File: RM20.024

Request for further information under section 92(1) of the Resource Management Act 1991 (the Act) – Application Number RM20.024

Thank you for your application for various consents relating to Deepdell North Stage III Project.

Figure 1: Watercourse map. The western tributary of Highlay Creek that could be impacted by discharges is indicated by red oval, the Gully Stream which will be reclaimed is indicated by the purple oval and the Highlay Tributary that will be culverted is indicate by the orange oval.

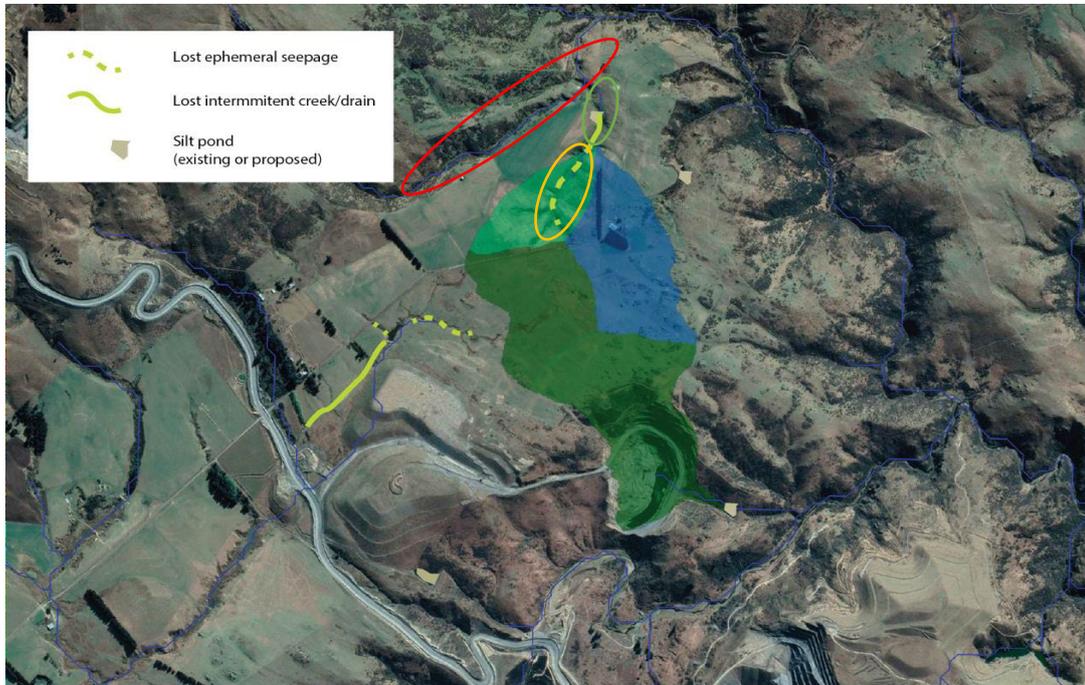
20. Provide the likely contaminant concentrations in both Highlay Creek and its Western Tributary (location shown in appendix 1) and proposed water quality standards for these creeks that can be applied in consent conditions. For nutrients, these standards should be set to control plant growth rather than toxicity.

21. Provide an assessment of the effects of culverting the "Highlay Tributary" (location shown in appendix 1), particularly around construction effects.
